Our Case Number: ABP-321776-25

Re: BusConnects Galway: Dublin Road Development
R338 Dublin Road, Galway City.

**Bus Connects Dublin Road
Galway Planning
Application & CPO
Submission on behalf of
HSE – Merlin Park
University Hospital
Campus**

ABP Pl. Ref: 321776
CPO Case Ref: 321882

Figure 2 - Bus Connects at MPUH Entrance

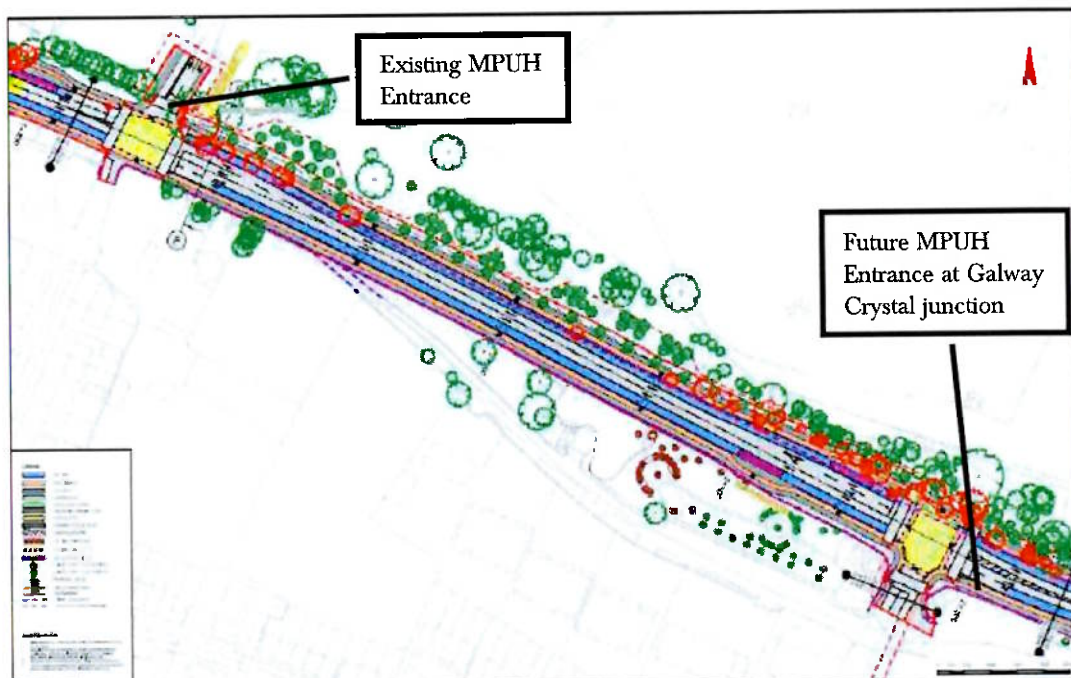
From the above, it is understood that the Bus Connects scheme proposes to upgrade the existing entrance to MPUH to a signalised junction to incorporate it into the proposed Bus Connects. While the HSE welcomes the project, it wishes to highlight a number of significant concerns raised in this submission. Accordingly, a summary of each of the concerns are provided below and expanded upon in greater detail in the following sections of this document.

Figure 6 Preliminary Option for development of MPUH Entrance

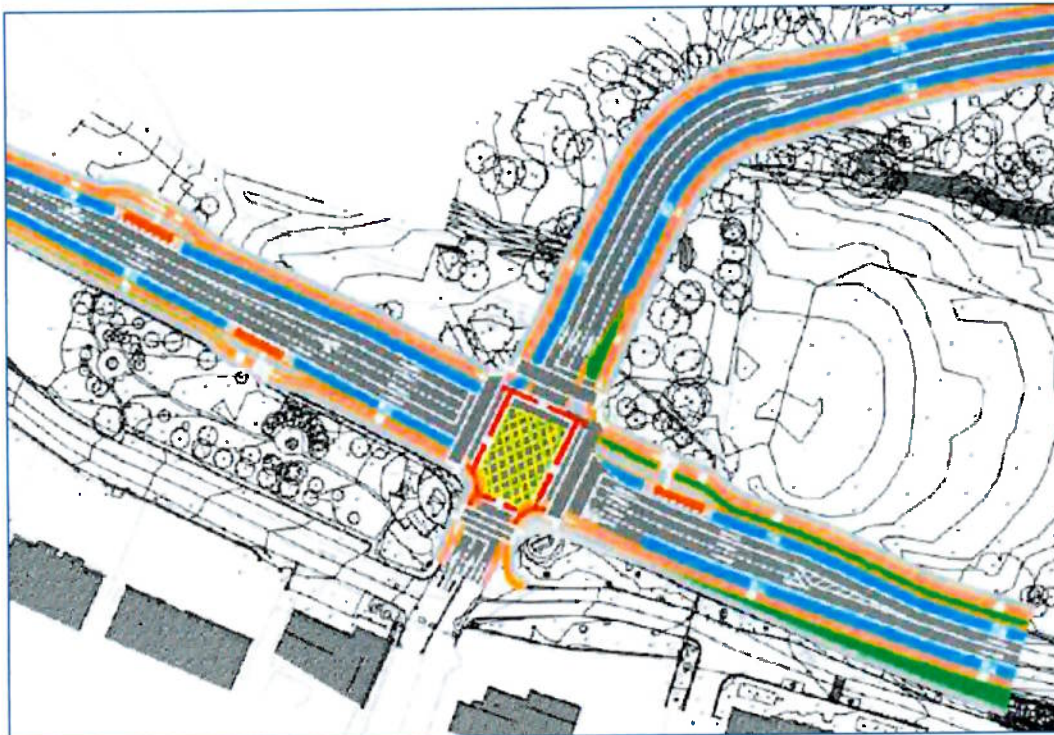
MKO would contend therefore, that the proposed Bus Connects Dublin Road project is inconsistent with the GTS and the GCDP (Objective 4.8) as it fails to make even a cursory provision for the requisite pedestrian, cycle and public transport infrastructure at the Dublin Road/Galway Crystal junction, the requirement for which is clearly stated in the GTS and GCDP. Again, it is not suggested that the Bus Connects Dublin Road should provide the full extent of the infrastructure upgrade required i.e. linking the Dublin Road to the existing internal MPUH road network, but the design of the Dublin Road/Galway Crystal junction should provide a fourth arm (to serve MPUH), and the overarching junction design in respect of signals, crossings, bus and cycle lane provision, should reflect this.

Furthermore, the failure to provide a section off the junction for the fourth arm or to provide associated signals, crossings, bus and cycle lane provision has the potential to make a future development proposal on the part of the HSE for this infrastructure, a very challenging endeavour. In the event that the Bus Connects Dublin Project receives planning permission and/or is constructed prior to any future 'fourth arm' proposal, the HSE will, in MKO's view, likely face opposition from the National Transport Authority and/or GCC in the context of a planning application, where the HSE will require at the very least to redesign a permitted junction (in the event Dublin Road Bus Connects is not completed before HSE receive planning permission) or to undertake significant physical alterations to a recently constructed NTA project (in the event Dublin Road Bus Connects is completed before HSE receive planning permission). Therefore, the Dublin Road Bus Connects project as currently proposed may prejudice the HSE in securing planning permission for the subsequent development of a fourth arm on the Dublin Road/Galway Crystal junction which is enshrined in Objective 4.8 of the GCDP.

RPS have been commissioned to prepare a draft Feasibility Assessment (Appendix 1 of this submission). The draft design includes for a fourth arm to the junction, to provide associated signals, crossings, bus

Figure 8 Extract from drawing no. BC/GDR-DM/03 (MKO emphasis included)

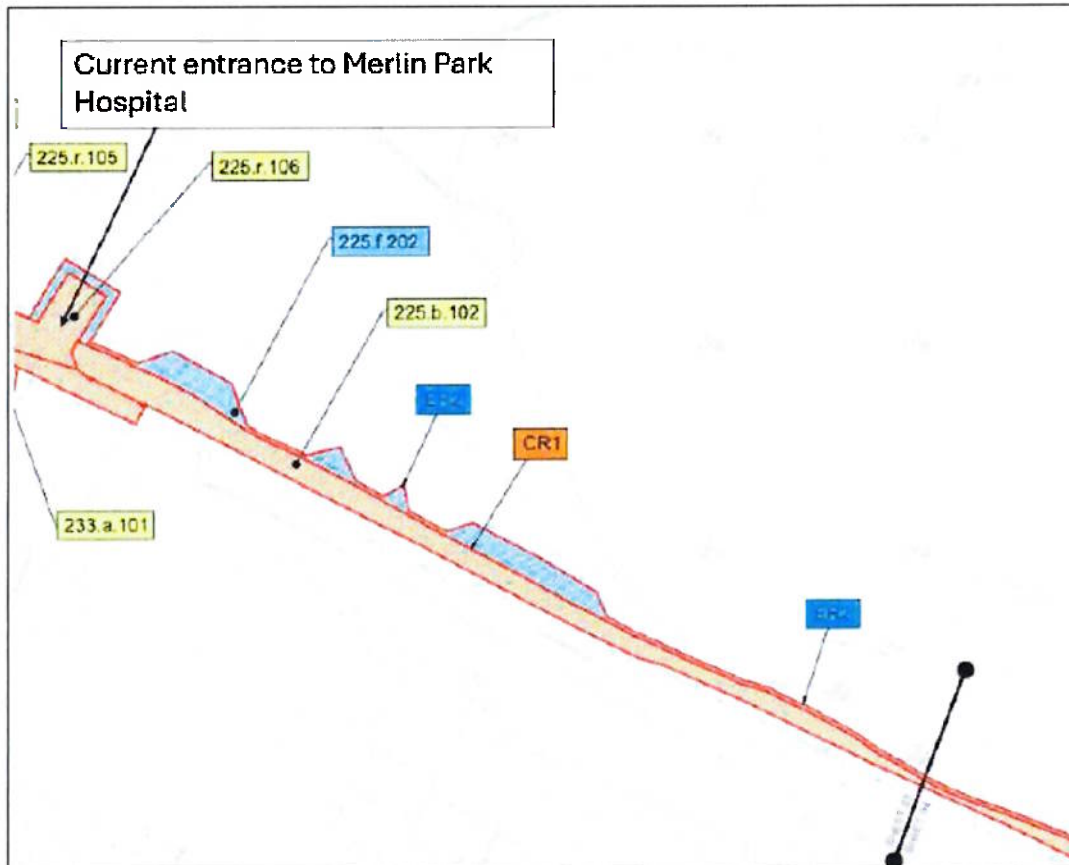
The HSE is fully supportive of the scheme in principle and welcomes the enhanced public transport provision in Galway City. However, concerns are expressed that the proposed land take for the BusConnects Project may be insufficient in the context of what our client considers to be the requisite works at the Dublin Road/Galway Crystal junction and as described in Section 7 above i.e. the making of provision for a fourth arm on this junction.

In MKO's view, in order for the planning application for the proposed Bus Connects project to be consistent with the GTS and GCDP, the design of the project must take account of providing for a fourth arm on the Dublin Road/Galway Crystal junction. The provisional design of the fourth arm on this junction, as illustrated in Figure 6 highlights that the CPO land take is insufficient to facilitate provision for an upgraded junction and fourth arm to MPUH. We respectfully request that the Board would confirm this interpretation during the assessment of the subject planning and CPO applications. In the event the Board concluded that this interpretation is correct, the extent of the CPO land take at the interface between MPUH and the Dublin Road/Galway Crystal junction is considered to be insufficient to accommodate the extent of the works required.

On this basis, the HSE wish to seek assurance that the project has adequately accounted for the maximum necessary land requirements, rather than a minimal allocation. The HSE is particularly concerned that, during the delivery phase, additional land may be required to provide for the full extent of upgrade works that are required, potentially triggering a new CPO process. To avoid delays and complications later in the process, the HSE requests that the BusConnects Project thoroughly assess and make provision for the acquisition of the requisite lands as part of this process. These matters should be considered in the context of the narrative set out in Section 7 above.
